Nomination Form
Anadromous Waters Catalog

Region Southeastern USGS Quad(s) BERING GLACIER A-3, ICY BAY D-2 & D-3
 Anadromous Waters Catalog Number of Water Body 191-20-13400-2033-3005 (-4035)
 Name of Water Body Lydick Creek USGS Name Local Name
 Addition Deletion Correction Backup Information

Nomination # <u>25-598</u>	<u>[Signature]</u> Fisheries Scientist	<u>9/24/2025</u> Date
Revision Year: <u>2026</u>	<u>[Signature]</u> Habitat Operations Manager	<u>9/24/25</u> Date
Revision to: <input checked="" type="checkbox"/> Atlas <input checked="" type="checkbox"/> Catalog	<u>[Signature]</u> AWC Project Biologist	<u>8 Sept 2025</u> Date
Revision Code: <u>C-9, A-1</u>	<u>P. R.</u> GIS Analyst	<u>10/3/2025</u> Date

191-20-13400-2033-3005-4035

Figure 4.-191-20-13400-2033-3005-4035 addition map.

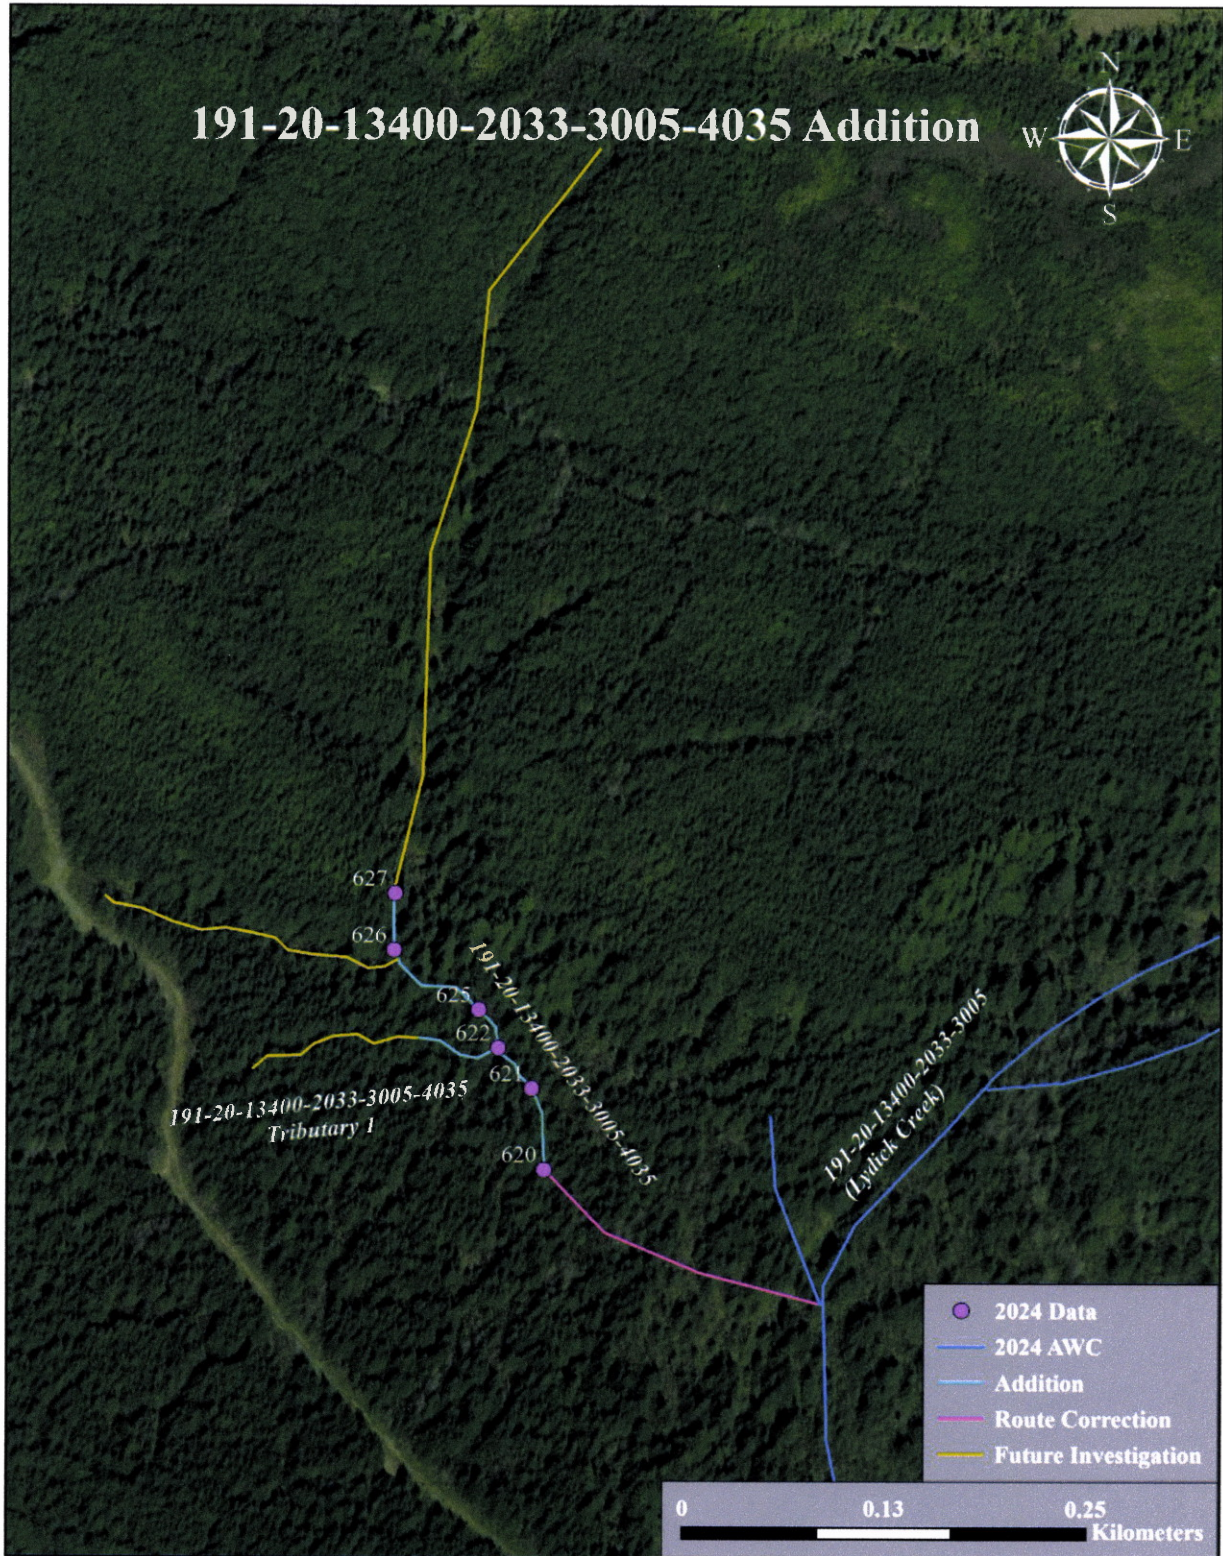
- UPDATE/ADJUST hydrography and corresponding stream mouth point of existing AWC Stream #191-20-13400-2033-3005 "Lydick Creek".
- UPDATE/ADJUST hydrography of existing AWC Stream #191-20-13400-2033-3005-4035.
- EXTEND existing AWC Stream #191-20-13400-2033-3005-4035 with COHO salmon REARING.
- + Please update using most recent .GDB with line, point, lake, polygon and barrier features located in O:\DSFR5AWC\Draft2026\GIS\Data\AWC2026_V\WkingV1_7April2025.gdb

****Important** Process Nom #25-593 and #25-597 first****

Map #1

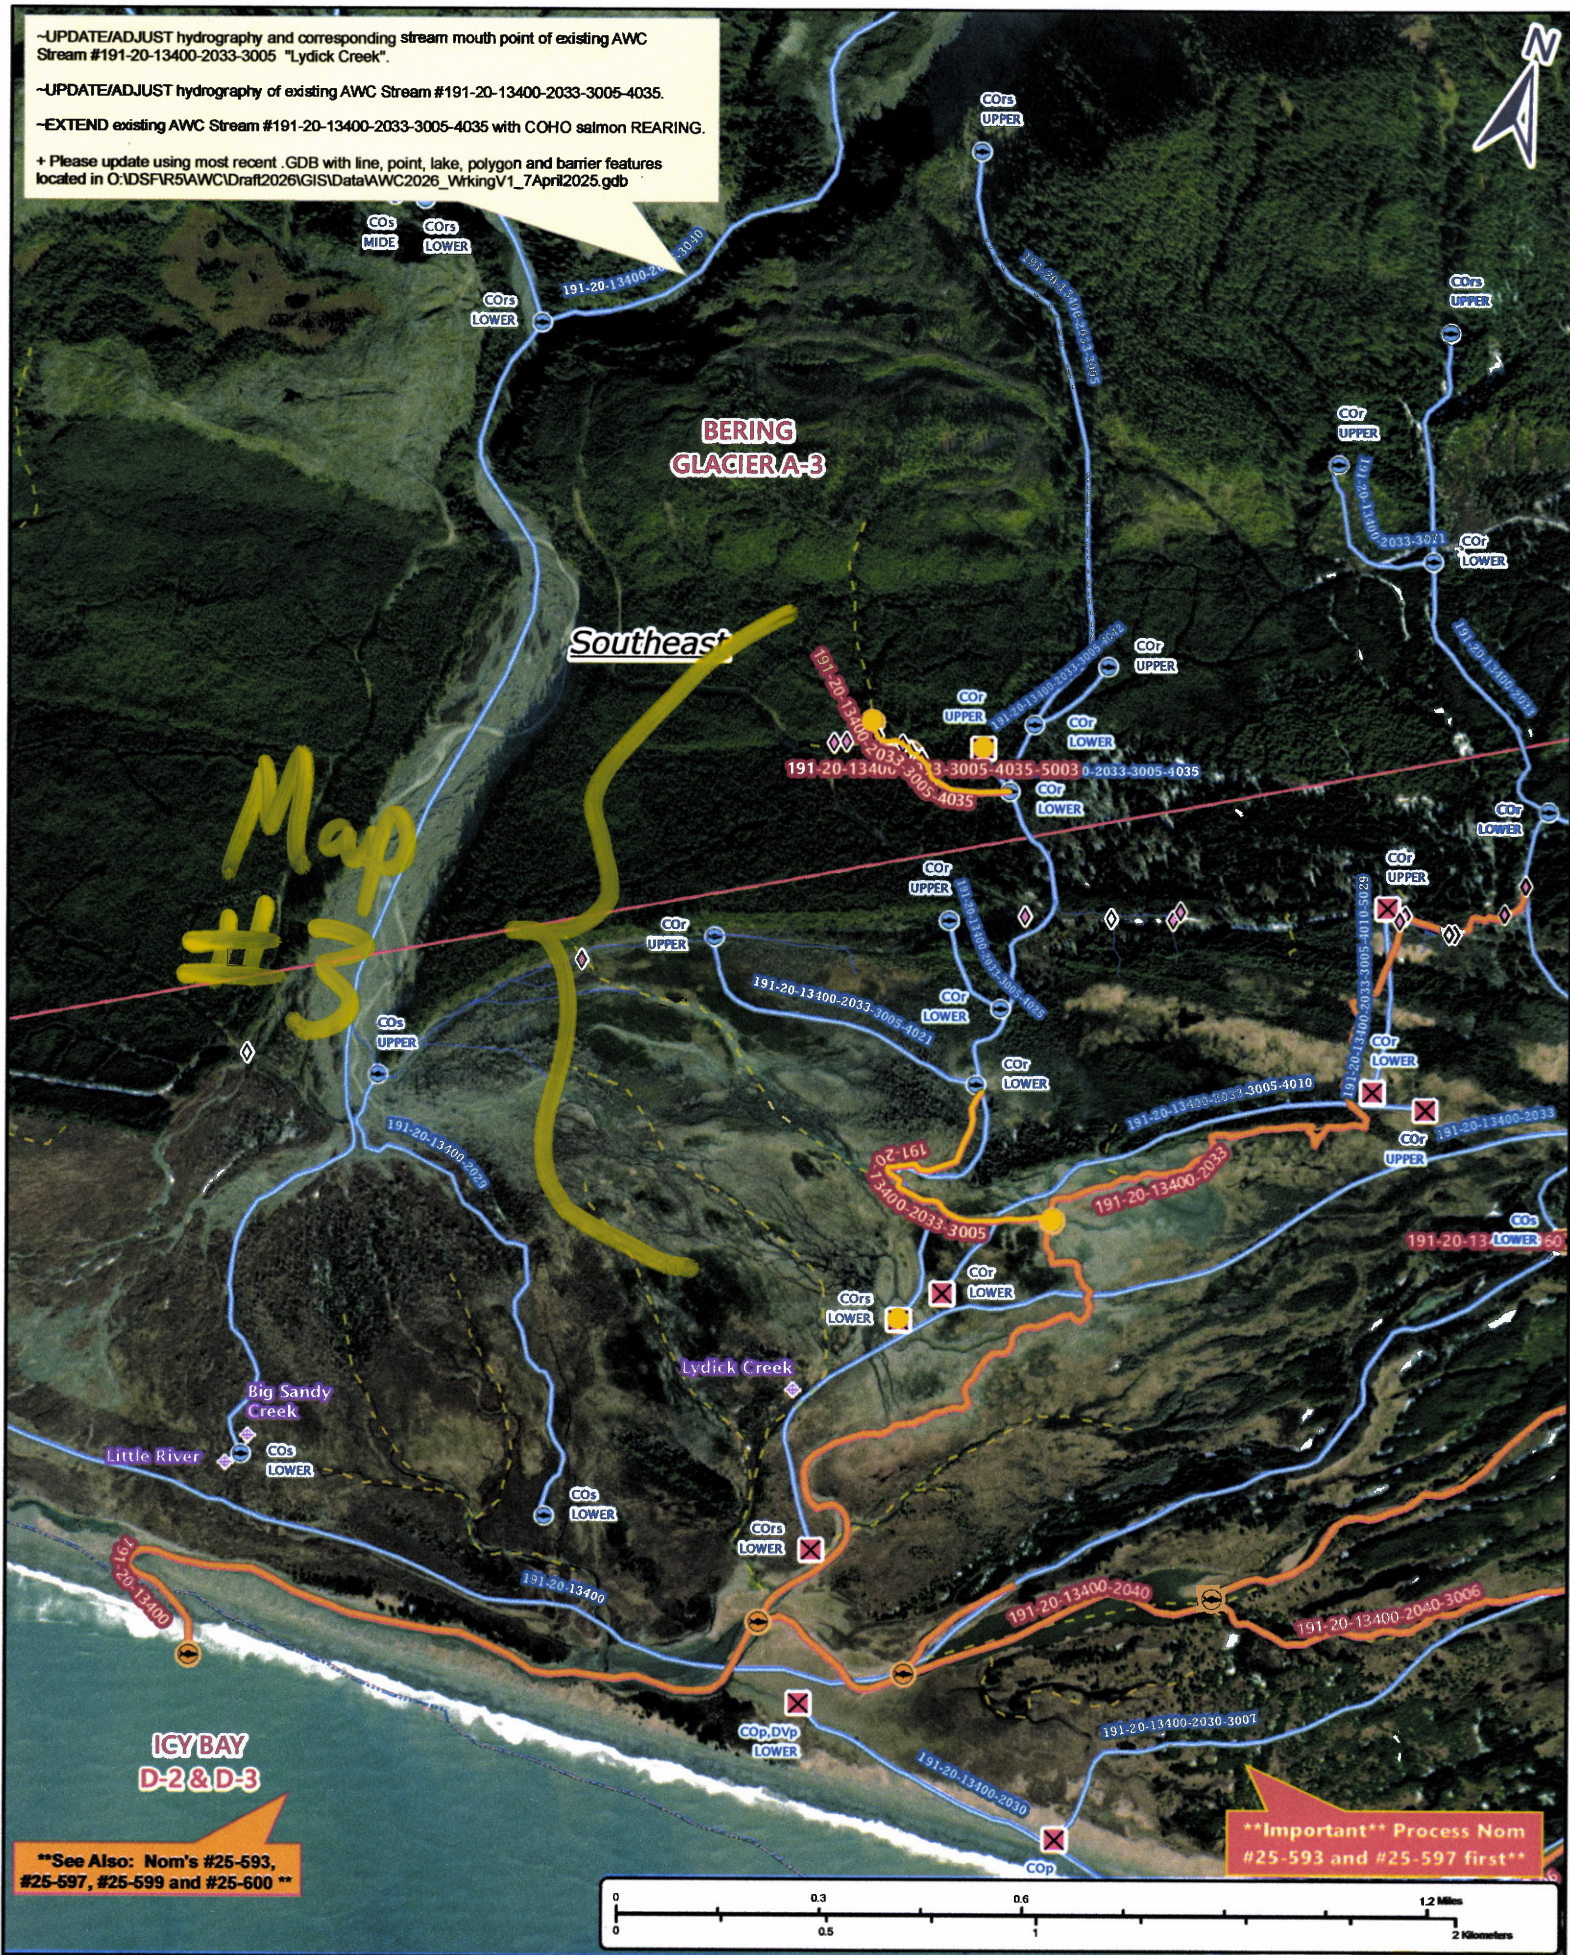
-UPDATE/ADJUST hydrography and corresponding stream mouth point of existing AWC Stream #191-20-13400-2033-3005 "Lydick Creek".

-UPDATE/ADJUST hydrography of existing AWC Stream #191-20-13400-2033-3005-4035.

-EXTEND existing AWC Stream #191-20-13400-2033-3005-4035 with COHO salmon REARING.

+ Please update using most recent .GDB with line, point, lake, polygon and barrier features located in O:\DSFR5AWC\Draft2026\GIS\Data\AWC2026_WorkingV1_7April2025.gdb

****Important** Process Nom #25-593 and #25-597 first****

Map #2

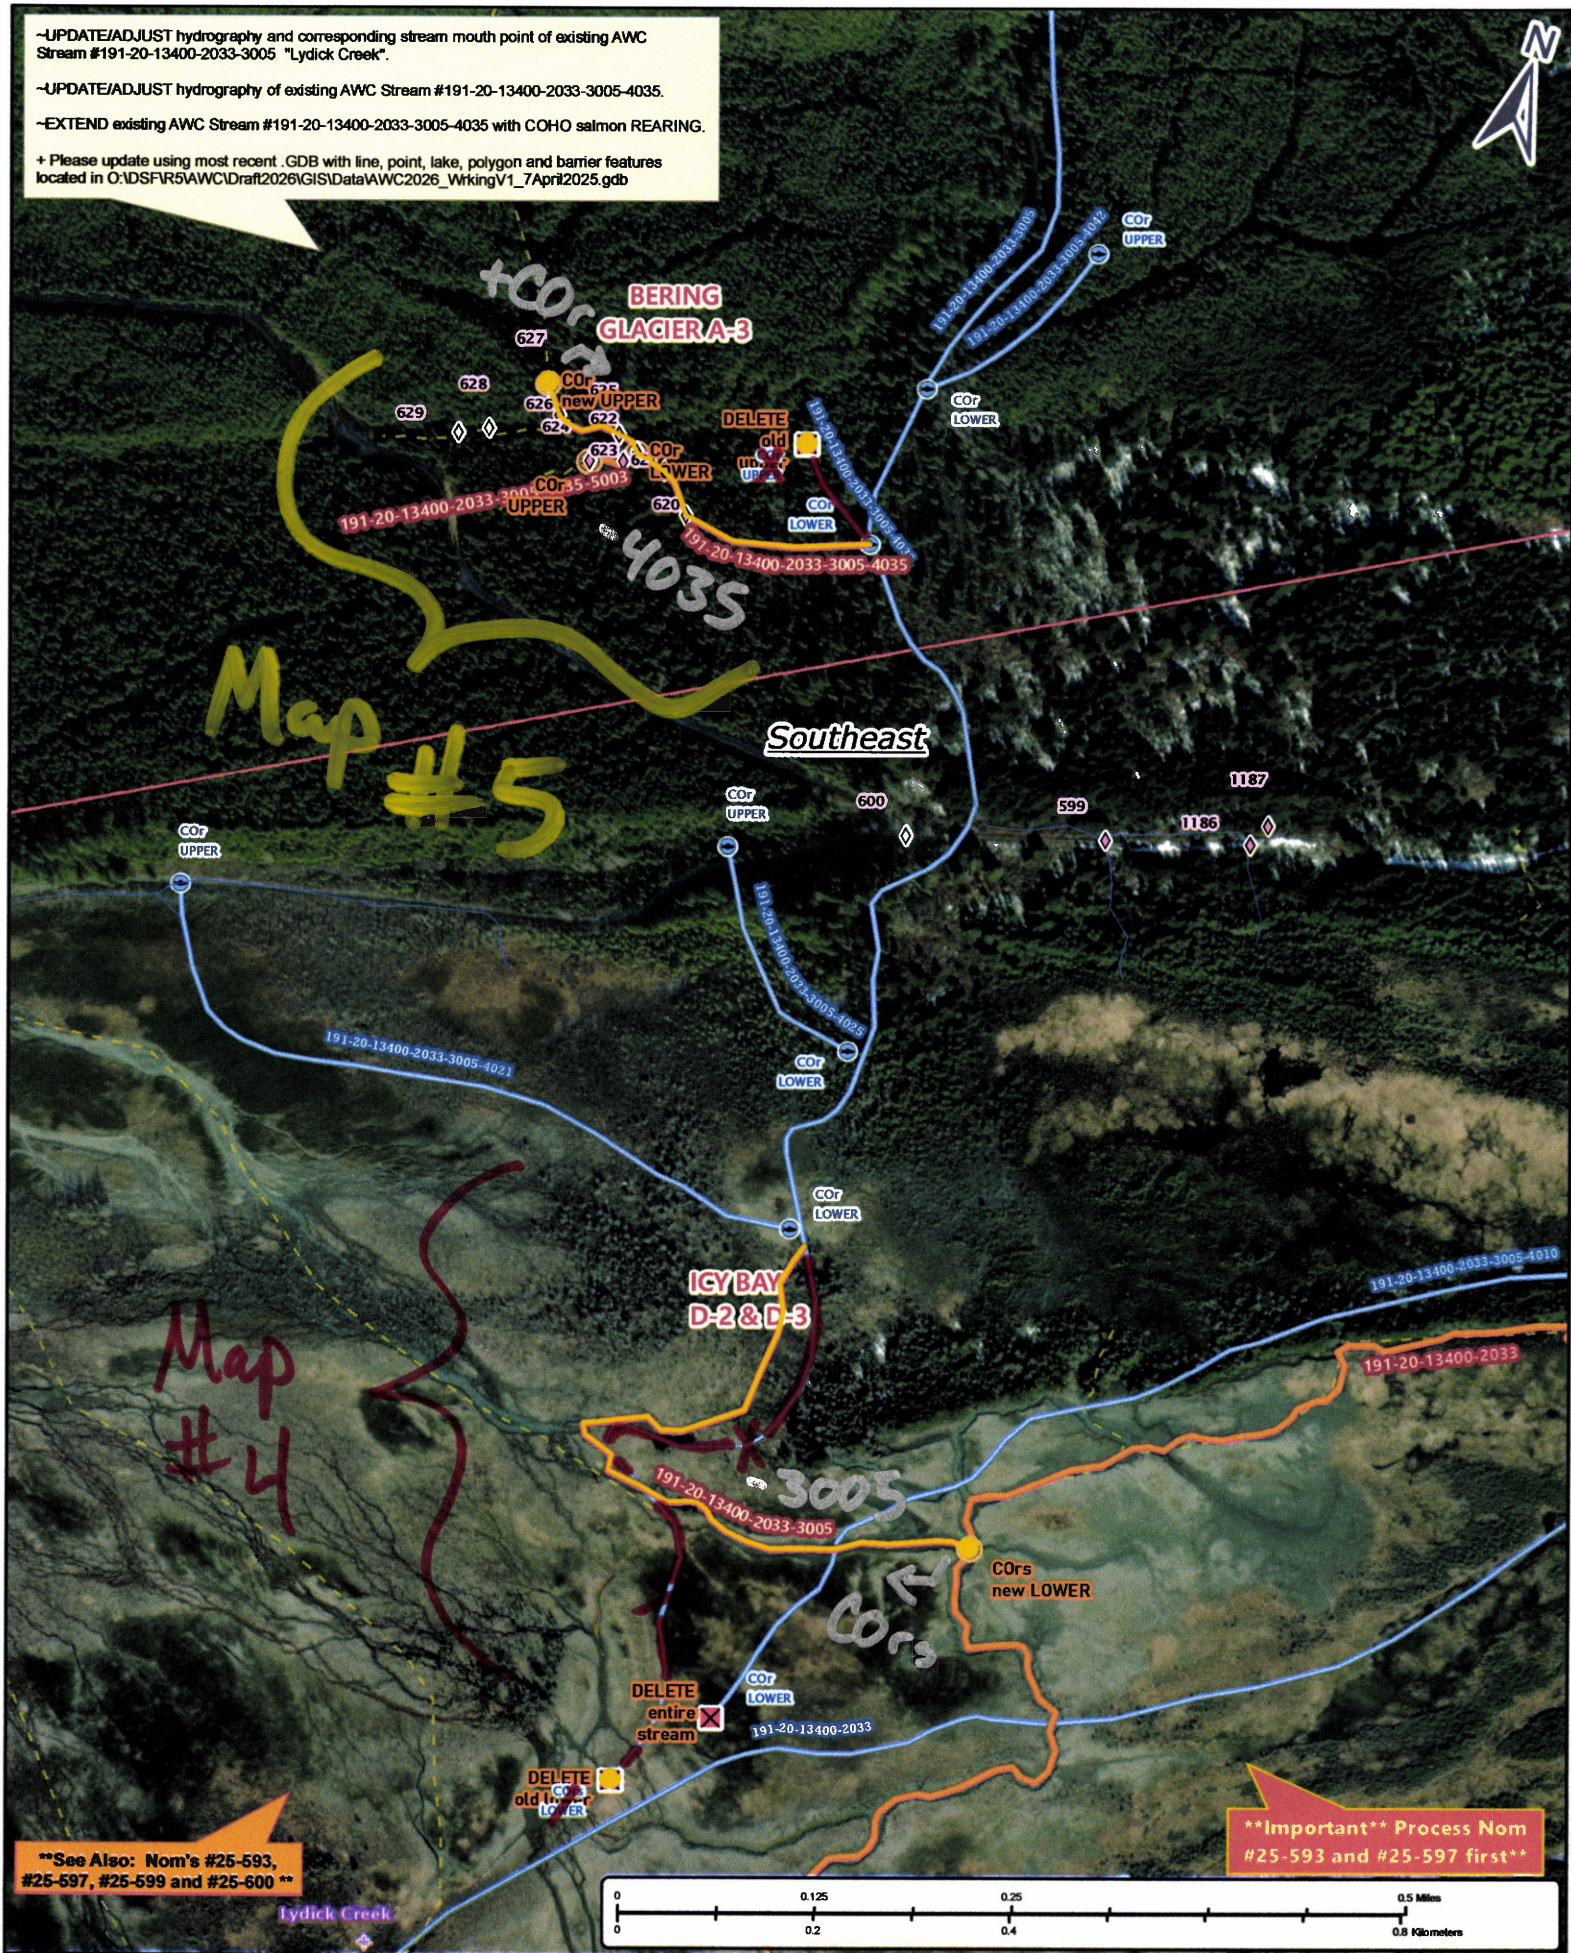
-UPDATE/ADJUST hydrography and corresponding stream mouth point of existing AWC Stream #191-20-13400-2033-3005 "Lydick Creek".

-UPDATE/ADJUST hydrography of existing AWC Stream #191-20-13400-2033-3005-4035.

-EXTEND existing AWC Stream #191-20-13400-2033-3005-4035 with COHO salmon REARING.

+ Please update using most recent .GDB with line, point, lake, polygon and barrier features located in O:\DSFR5AWC\Draft2026\GIS\Data\AWC2026_WorkingV1_7April2025.gdb

****Important** Process Nom #25-593 and #25-597 first****
